Hub and Transition

Building Form:	► Low-rise	► Context-sensitive height (adj. to residential)
	► Reduced restrictions on materials and aesthetic "style"	► Shared entries
	► Functional/form characteristics	► Reduced automobile-dominant site design
		► Low- to mid-rise buildings
		► Unified street wall

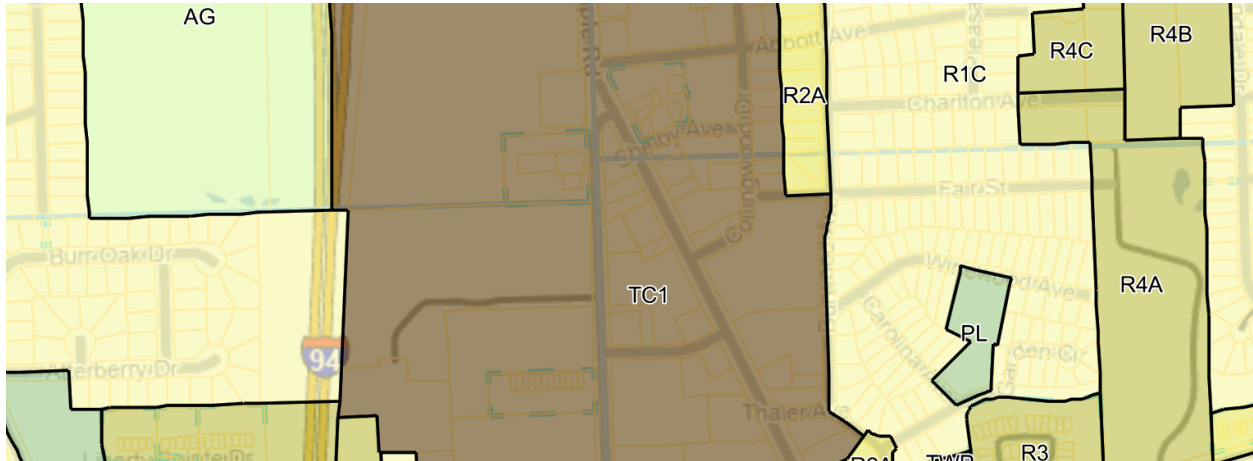
There is a much simpler solution -- In the "Building Form" section of the Transition District, change "low to mid-rise" to "low to high-rise."

That way, only low-rise buildings will be allowed near the Residential district, but high-rises will be allowed near Hub. Later, at the time of zoning, this principle can be implemented like the existing rules for TC-1.
